Reference: **335 Roosevelt Avenue**
RMA Application
Our File No.: 110098

The city had also provided comments on the Roosevelt Avenue Terminus Design of the Subject Site. The responses to the comments are as follows:

ROOSEVELT AVENUE TERMINUS

DRAWING NAME
FUNCTIONAL DESIGN

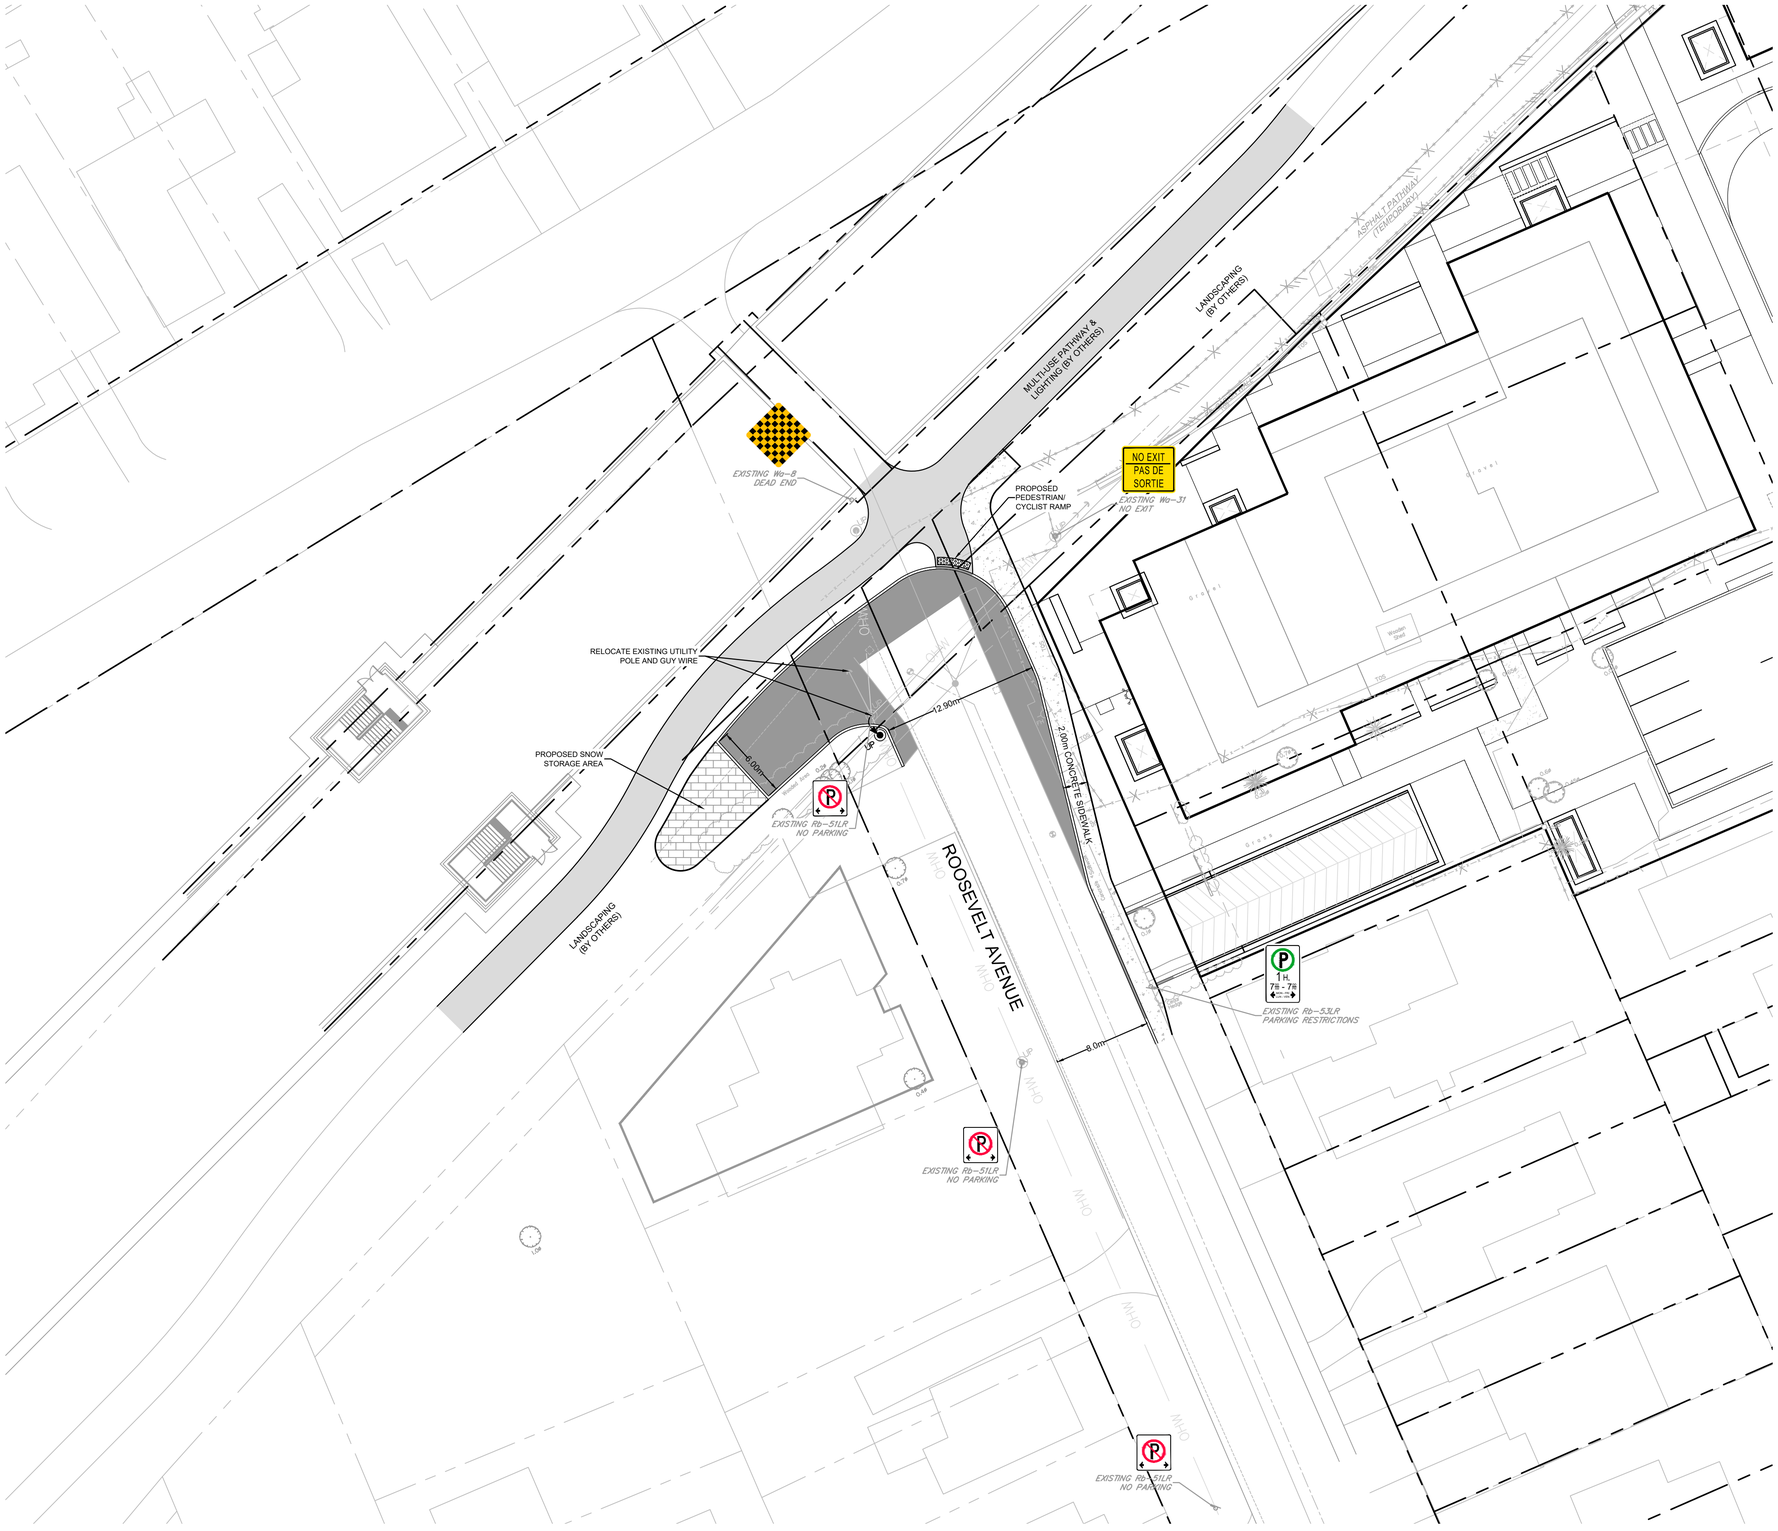
1. To aid turning and potentially limit the overhang of sidewalk during reverse, consider removing curb radius to the east of the utility pole, and instead provide a straight curb to facilitate egress. Refer to markup below.

2. On the west side of the functional design, maintain the alignment of the MUP proposed by Stage 2 LRT for longer to permit larger radii within the MUP “S-bend”.

3. Consider a 2.0m-wide sidewalk on the east side of Roosevelt Avenue.

Novatech Response
The design has been revised in accordance with the markup provided by the city. As discussed above, the relocation of the utility pole and guy wire is being coordinated with Hydro Ottawa.

Novatech Response
The design has been revised in accordance with the markup provided by the city.

Novatech Response
The design has been revised to include a 2.0m wide sidewalk.

TURNING MOVEMENT (MSU / GARBAGE TRUCK)

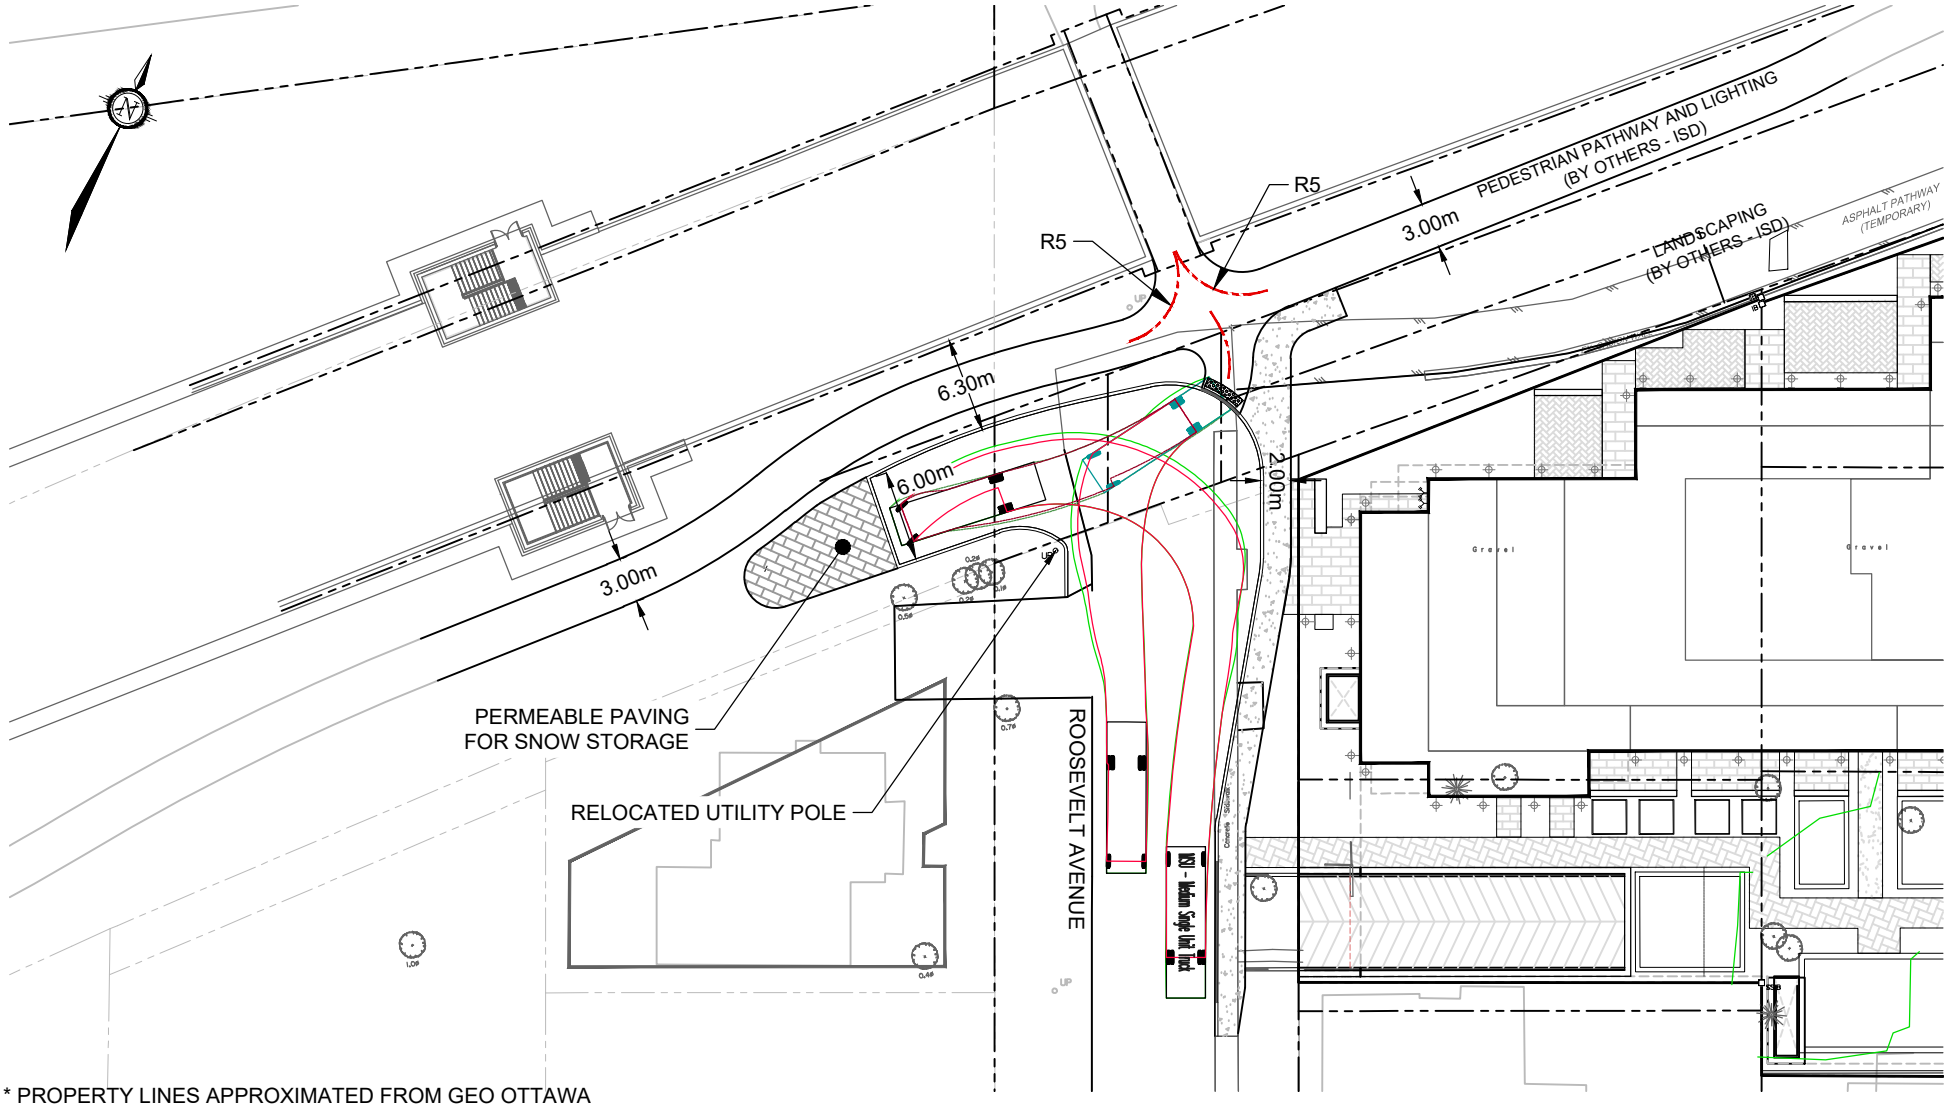
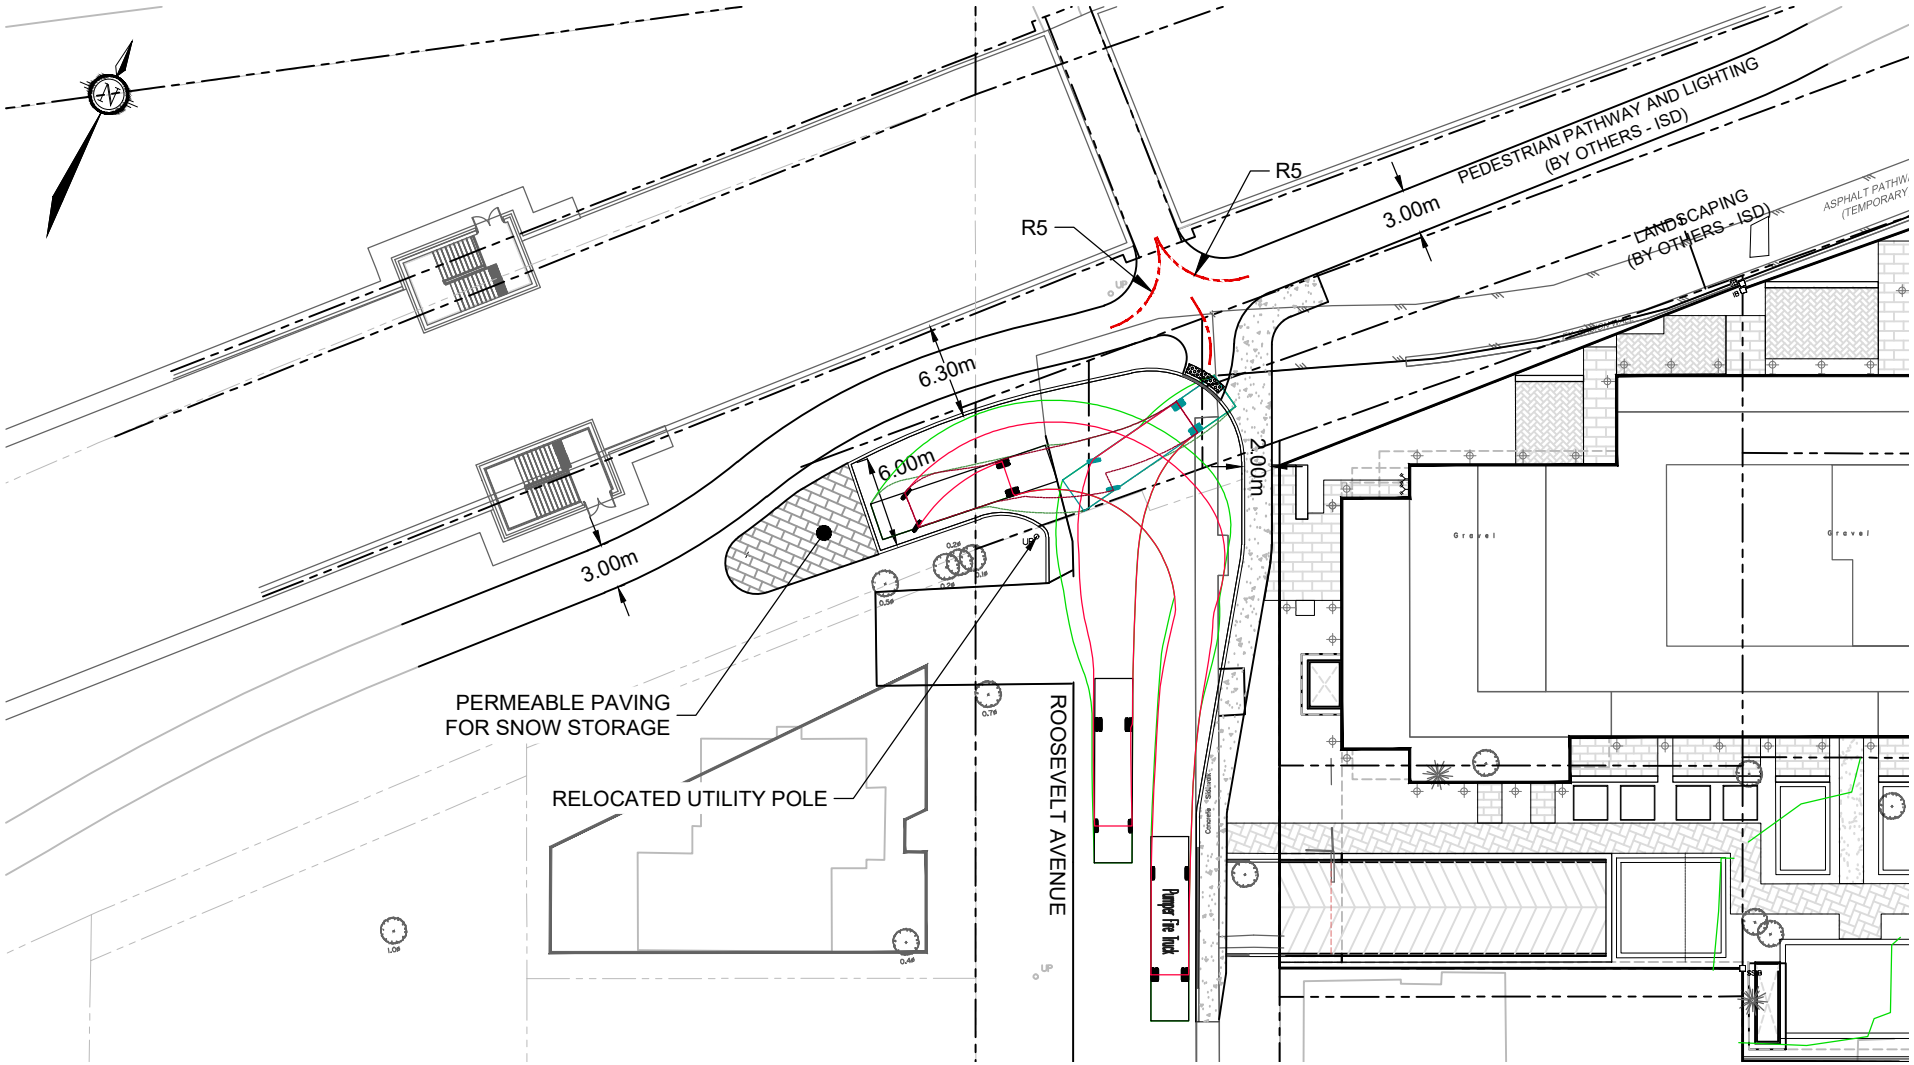
5. Turning movements show MSU & Fire Truck swept path encroaching over the MUP and the sidewalk while reversing. Road designs should allow vehicles to complete turns safely and

efficiently without the need for reversing over pedestrian and cycling facilities. Such reversing maneuvers could pose safety risks, especially in areas with high pedestrian activity. Consideration to relocate the utility pole is still recommended to limit/prevent this conflict, though AT Planning recognizes this has previously been requested and rejected.

Novatech Response
The available area is insufficient to accommodate a traditional cul-de-sac to eliminate backing up. The MSU (fire truck/garbage truck/moving vehicles) that has its overhang over the sidewalk while reversing is infrequent. Also, the loading procedures for the west building will be off Winston Avenue. Fire trucks will have flasher/sirens to enforce the right-of-way. As discussed above, the relocation of the utility pole and guy wire is being coordinated with Hydro Ottawa.
